Staff Report

Historic Review of New Construction

New Mixed-Use Development in Monteith National Register Historic District

File No. **HI-04-20**

2 WEST BUILDING ELEVATION
 A3.0 1/4" = 1'-0"
 0 5 10 15

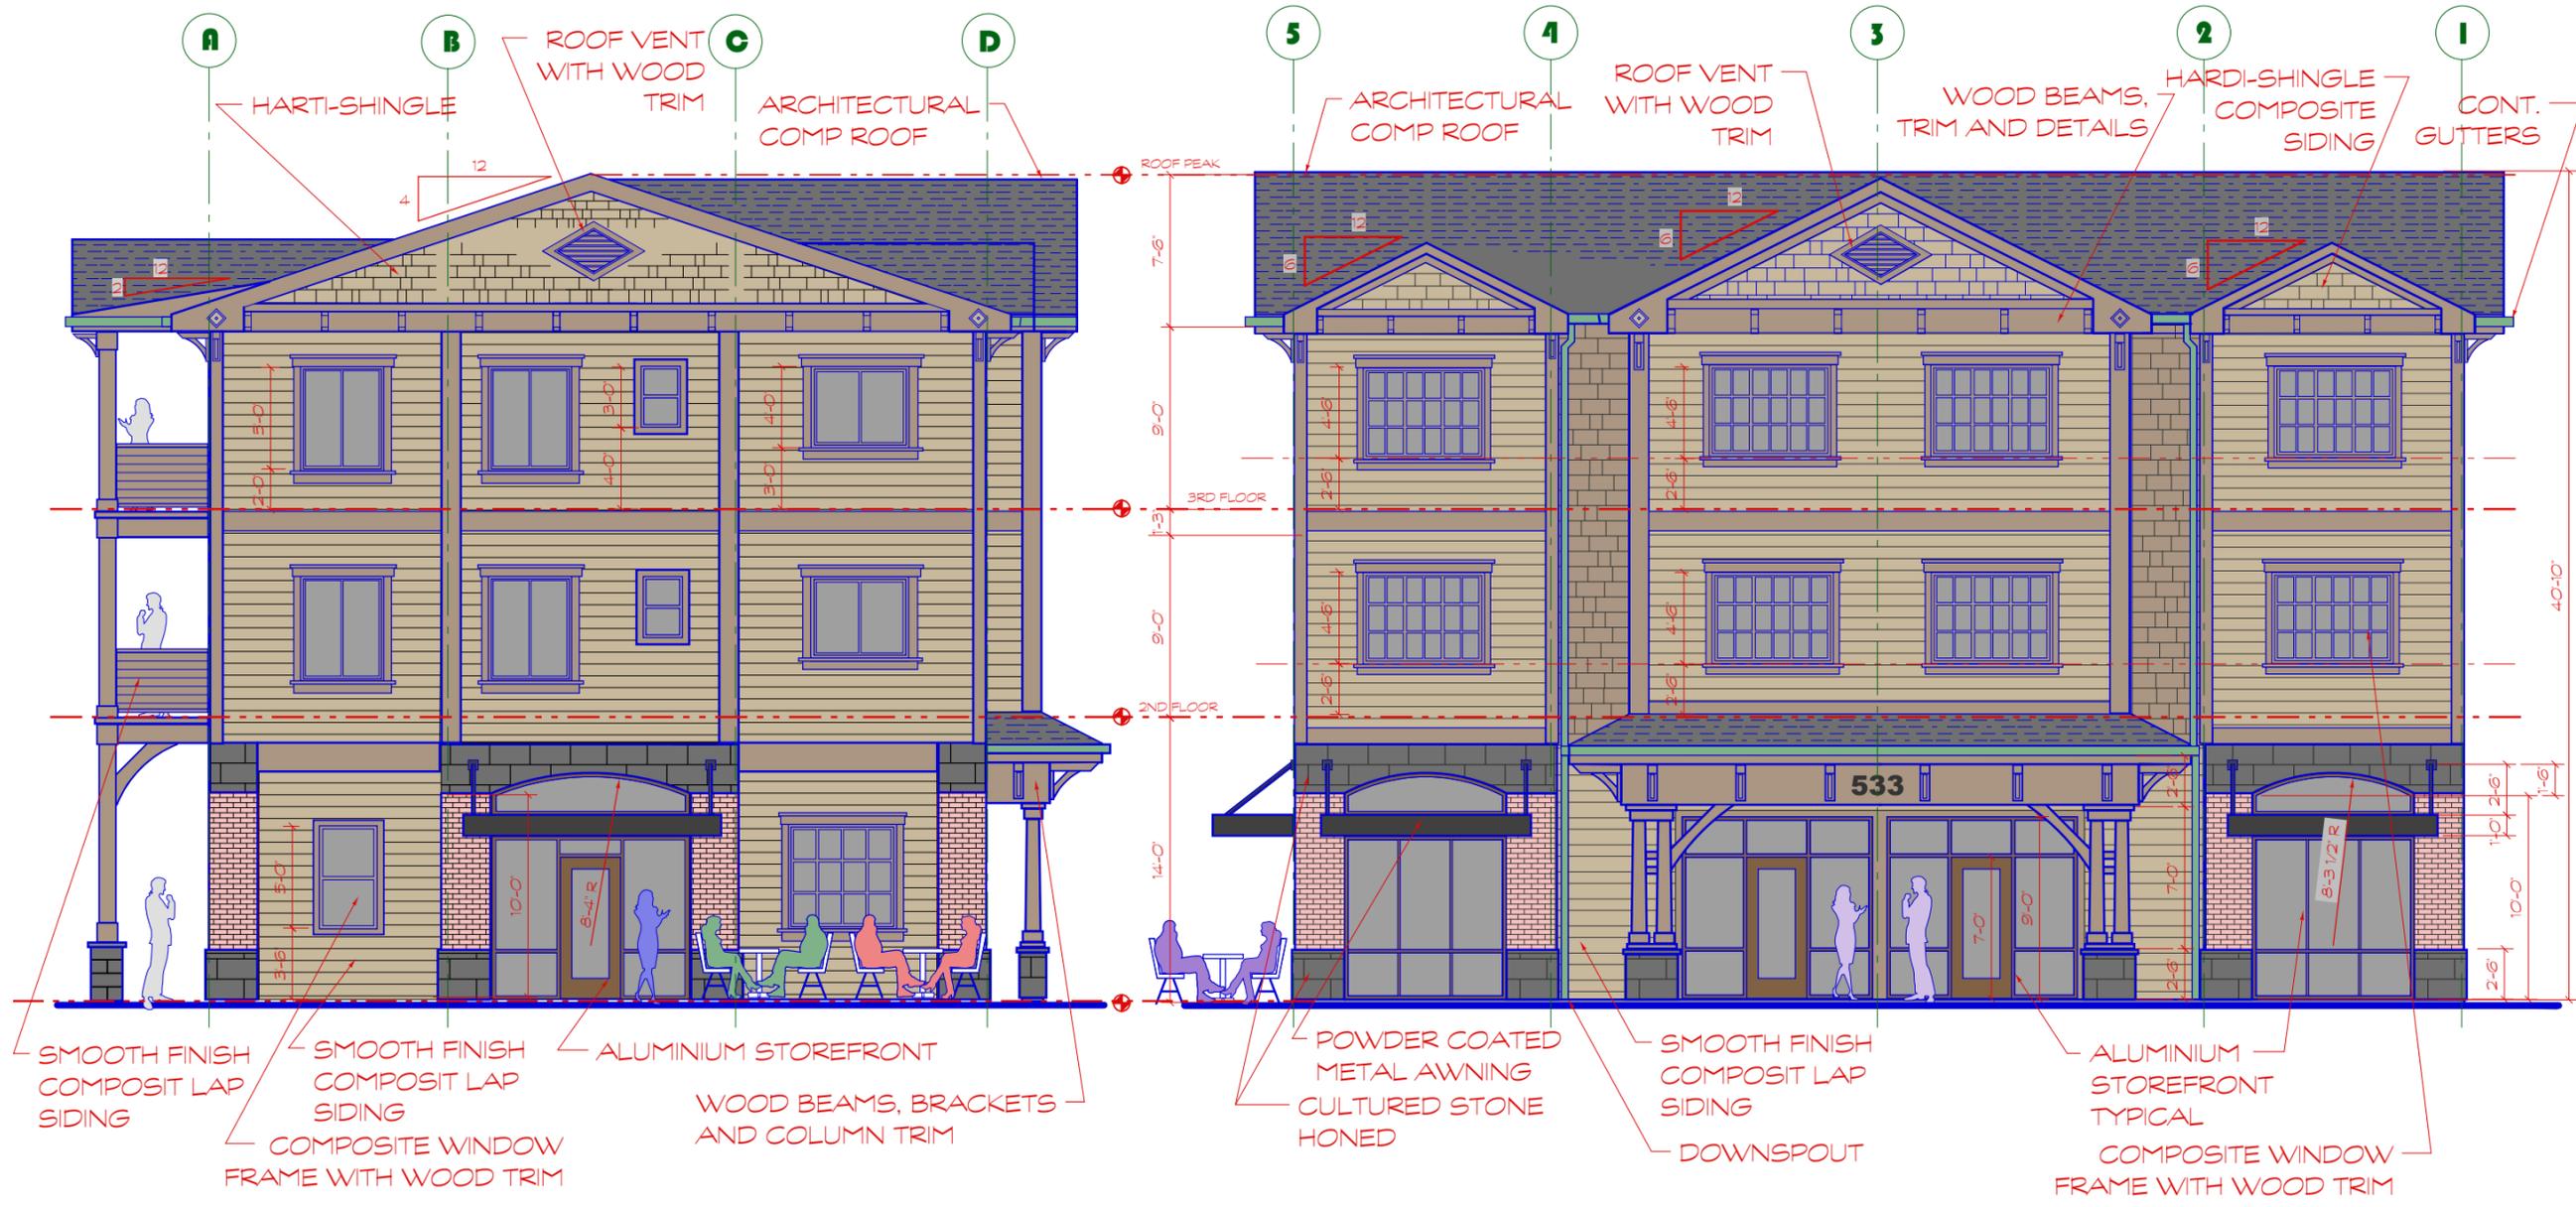
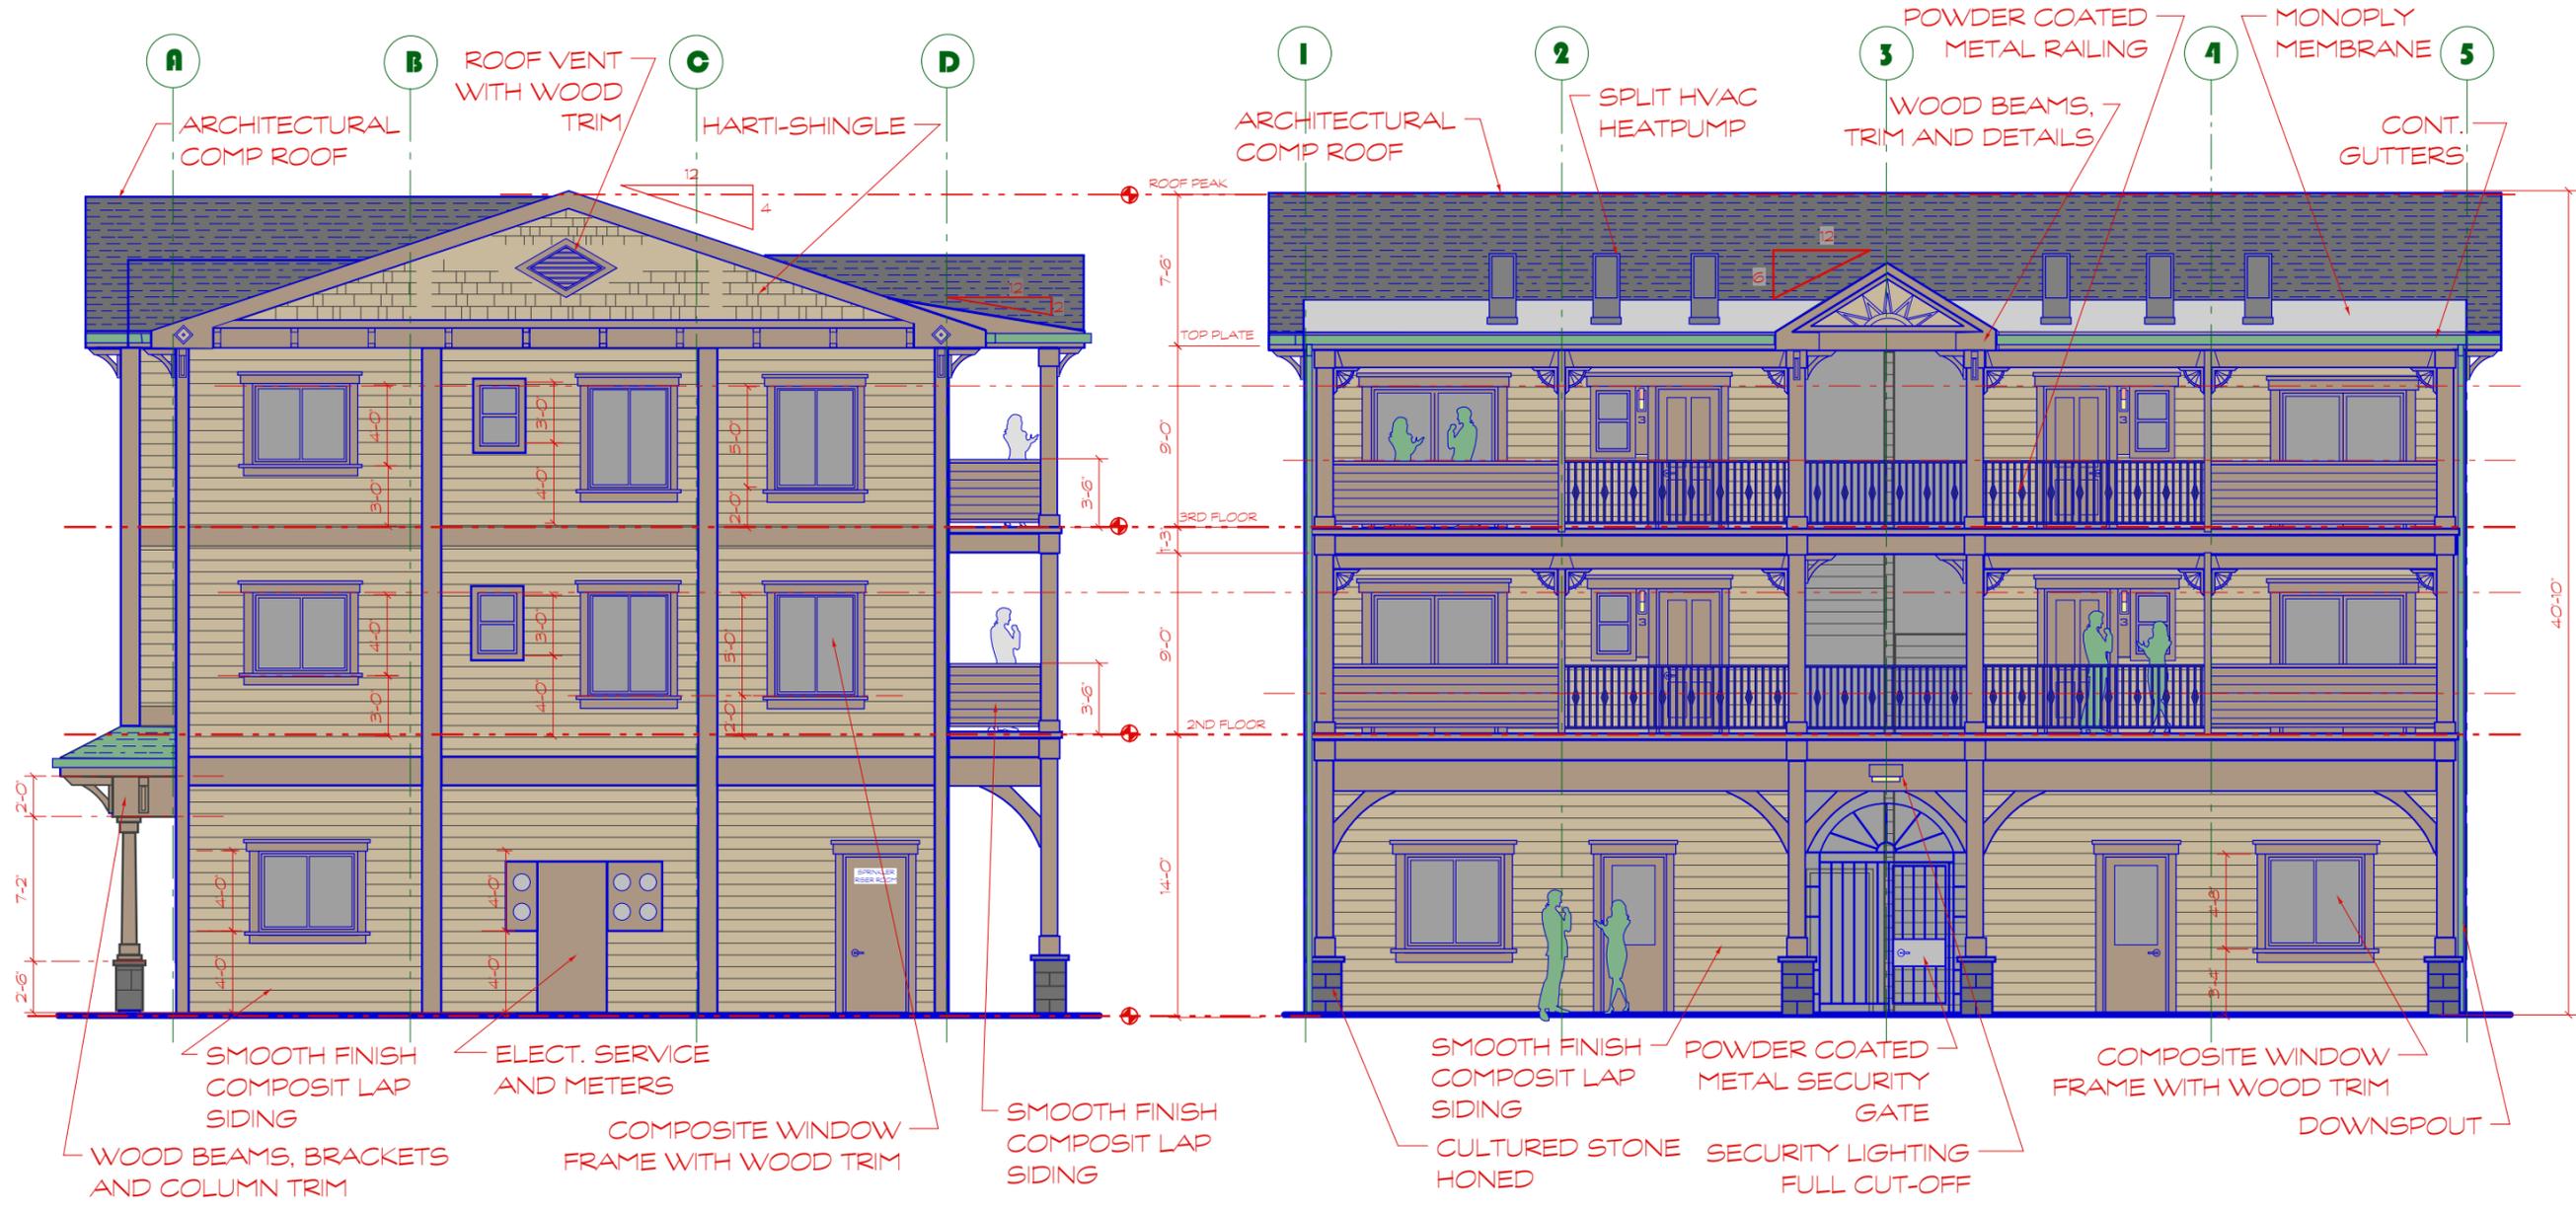
- 2.2 Buildings One and Two are each three stories tall, 57-feet-10-inches wide and 43-feet-6-inches deep with a total building area of 6,732 square feet (see Elevation Plans, Attachments B8 & B9).
- 2.3 In comparison with the abutting historic contributing single-family residential dwellings to the north and east, the proposed structures are approximately twice as wide and seven times as big.

- 2.8 Wall offsets. Offset wall planes on the primary facades of Buildings One and Two are also proposed to create visual interest and breaking up the massing of the structures. On the ground and upper levels of the front elevation, slight offsets are used to break up the wall plane into approximately 16.5-foot to 25-foot segments. The depth of the ground floor and upper floor recesses are one-foot-five-inches and two-feet-four-inches, respectively.

The proposed offsets break up the wall plane but are not deep enough to reduce the perceived mass and scale of the building. Offsets between main façade and porches of adjacent residential development in the district are found to be on average five feet deep. Therefore, condition of approval will require

- 2.13 Building One and Two are each proposed to be three stories tall measuring 33-feet-3-inches to the top of the wall and 40-feet-10-inches to the peak of the roof (overall height) (Attachments B.8 & B.9). The distance between the top of the third floor and peak of the roof is seven-feet-six-inches tall. The height of the first, second, and third stories are 14 feet, 9 feet, and 9 feet, respectively (Attachments B.8 & B.9). ADC 8.440 requires the height of the first story be a minimum of 14 feet when occupied by commercial or institutional uses in the DMU zone, which adds to the overall floor-to-ceiling height. However, the review body may grant flexibility in meeting any of the design standards for development subject to historic review under Article 7, to achieve historic compatibility.

- 2.16 A reduction to the overall and first-floor wall height of Building One and Two is required to maintain and respect the height of abutting residential dwellings, particularly to the east of the subject site. A minimum four-foot reduction to the overall height including a minimum two-foot reduction to the first-floor wall height is required to reduce the disparity in height and horizontal floor alignment between the proposed and existing abutting development.

- 3.6 Side Elevation Windows: On the side elevations, a variety of window types (i.e. multi-paned, sliders, one-over-one) are incorporated, which provides inconsistency in architectural style and detail. This is

especially noticeable on the side street facing elevation of Building Two, where windows vary in functionality, size, style, and arrangement.

- 3.7 Rear Elevation Windows: On the rear elevations, the applicant proposes composite framed windows. The second and third story windows on the rear elevation are not symmetrical with windows on the ground floor nor the same function and size per floor. Additionally, the window function (i.e. sliders, one-over-one) and sizes also differ between the ground floor to upper floors.

- Condition 3* Prior to issuance of a building permit, the applicant shall submit a revised elevation plan(s) and/or floor plans to the Community Development Department for review and approval that show a minimum five-foot deep offsets in the same locations as proposed (i.e. primary street facing facades) of Building One and Two.

- Condition 4* Prior to issuance of a building permit, the applicant shall submit a revised elevation plan(s) to the Community Development Department for review and approval that shows the height of Building One and Two reduced a minimum of four feet overall including a minimum two-foot reduction to the first-floor wall height.

- Condition 5* Prior to issuance of a building permit, the applicant shall submit revised plan(s) and/or window and door schedules to the Community Development Department for review and approval that illustrates and/or describes the following: 1) all first-floor storefront windows as fixed with aluminum frames and clear/untextured obscuring; 2) all transoms to be rectangular and multi-paned; 3) all windows other than storefront and transoms to be uniformly sized and spaced, single- or double-hung, with either between the glass, or simulated divided grids, and clear/untextured obscuring; 4) all doors to be the same style (i.e. four raised paneled or half lite) and constructed of fiberglass, wood, or steel. Prior to the issuance of an occupancy permit, all doors and windows must be installed as proposed and/or approved.
